**POWERLEAGUE,
MANCHESTER NICHOLLS**

**Surface Water Drainage Strategy Technical Note
Condition 13
Planning Permission Ref 139661/FO/2024**

Rev C 24/10/24

LLFA Comments 17/09/2024

8946-MJM-XX-XX-DR Drainage Layout

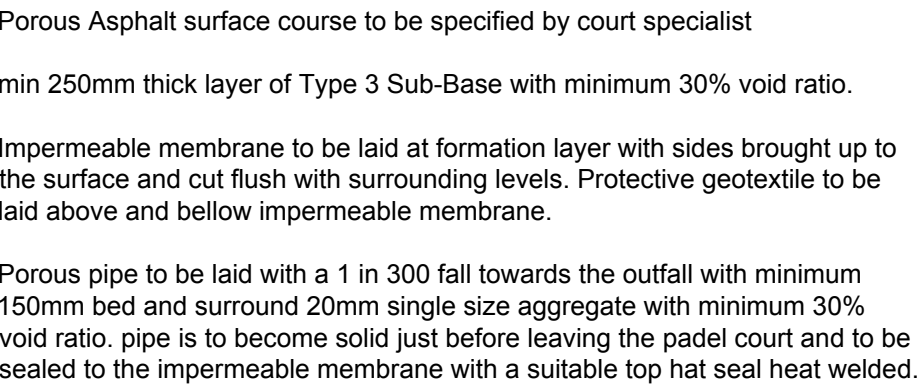
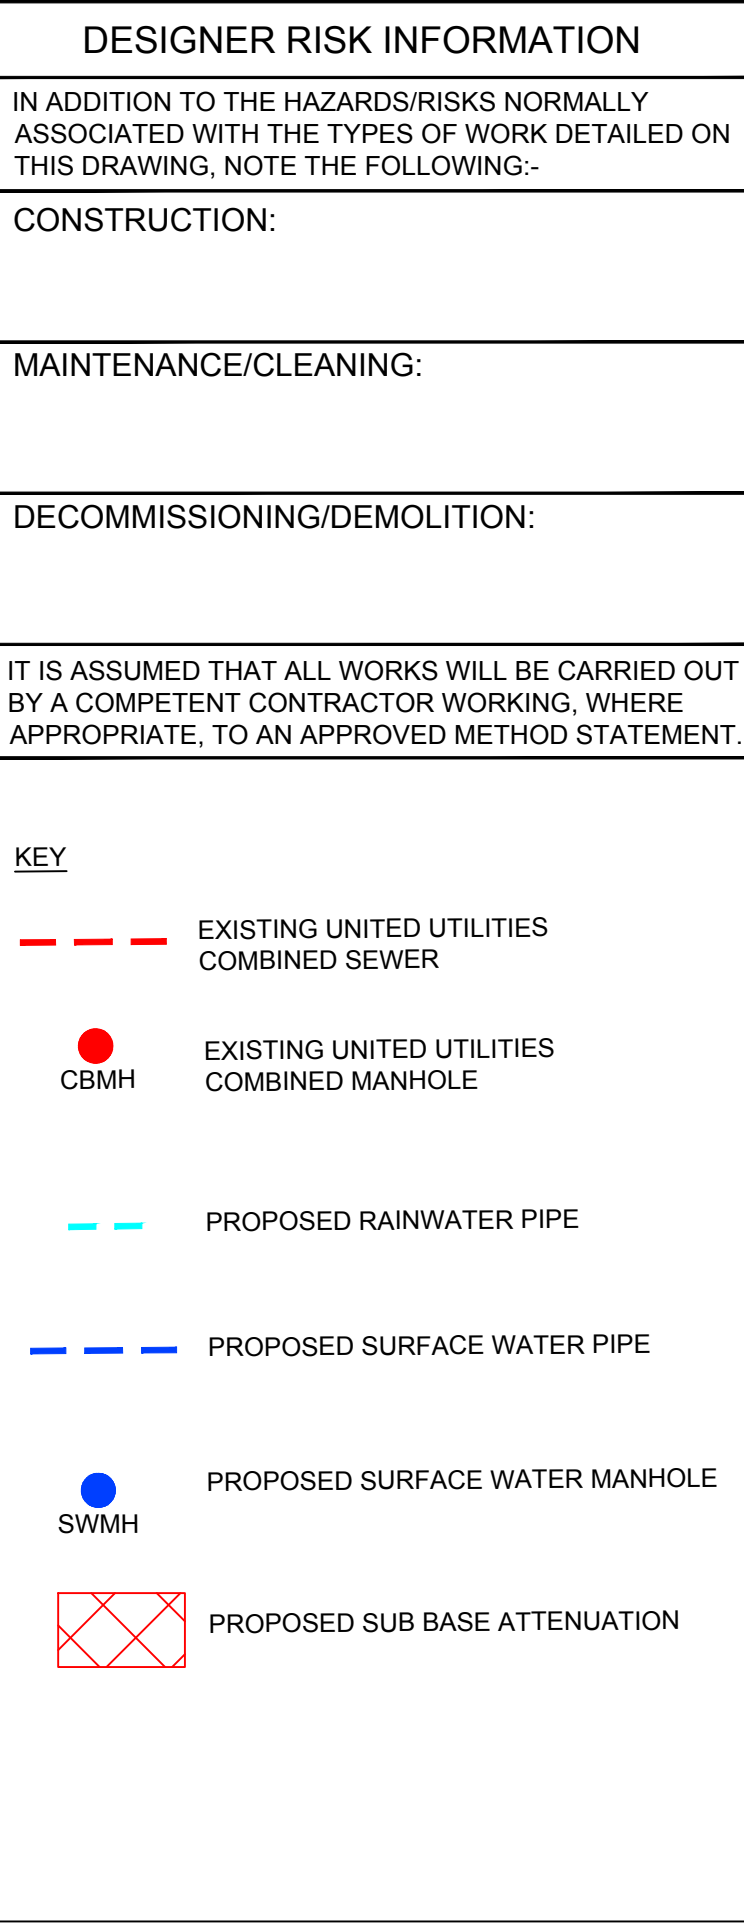
Finalised surface water drainage layout including all components, levels, connectivity and proposed	Y	N	<standard comment: The applicant must present a consistent package to discharge this condition (Including all layouts and calculations). The layout and	Pipe references have been added to the plan to ensure the layout and calculations can be referenced with one another.

overland flow routes for extreme events.			calculations must be jointly updated to account for any edits required. When preparing a resubmission, the applicant must ensure that the drainage layout and hydraulic calculations correspond, and that they can be cross-referenced for checks. This includes layout annotations and schedule printouts. >	
Hydraulic calculations of the proposed drainage system, including all design parameters. Results must demonstrate no flooding in the 1 in 30 and no flooding of buildings for the 1 in 100 + 45% Climate Change.	Y	N	The storage system used in the layout is a subbase which does not match with the type of storage system used in the hydraulic calculation which is a tank. Please resubmit the calculations to match the layout with appropriate porosity values.	Calculations have been updated to suit the granular sub base material with a 30% void ratio.
Where flows less than 5 l/s are proposed, a blockage risk assessment must be undertaken. If the risk cannot be adequately managed, a higher minimum discharge rate should be considered / agreed with relevant authority.	Y	Y

Construction details of flow control and SuDS components.	Y	N	Please provide construction details of the type of storage system used.	Annotated cross section added to the drainage layout
Details of how the scheme shall be maintained and managed after completion	Y	N	Please provide details on how the storage system is maintained and managed.	Additional information added to the maintenance schedule.

Decision Notice Clause	Contained in submission	Approvable standard	Further information required:	MJM Comments
Prior to the commencement of the development hereby approved, a surface water drainage layout for the development site shall be submitted for approval in writing by the City Council, as Local Planning Authority. This shall include the following:				
For surface water connections, evidence of agreement in principle from the relevant authority/service provider is required to ensure there is adequate spare capacity in the existing system taking future development requirements into account. An email of acceptance of proposed new connection will suffice.	Y	Y		
Details of surface water attenuation that offers a reduction in surface water runoff rate in line with the Manchester Trafford and Salford Strategic Flood Risk Assessment to greenfield runoff rate.	Y	Y		
Finalised surface water drainage layout including all components, levels, connectivity and proposed overland flow routes for extreme events.	Y	N	standard comment: The applicant must present a consistent package to discharge this condition (Including all layouts and calculations). The layout and calculations must be jointly updated to account for any edits required. When preparing a resubmission, the applicant must ensure that the	Noted the note to the pitches has been updated to suit the same volume as the calculations

P03	24.10.24	ATTENUATION VOLUME AMENDED	CB	CB
P02	26.09.24	UPDATED TO SUIT LLFA COMMENTS	CB	CB
P01	16.08.24	FIRST ISSUE	JB	CB
Rev	Date	Amendment
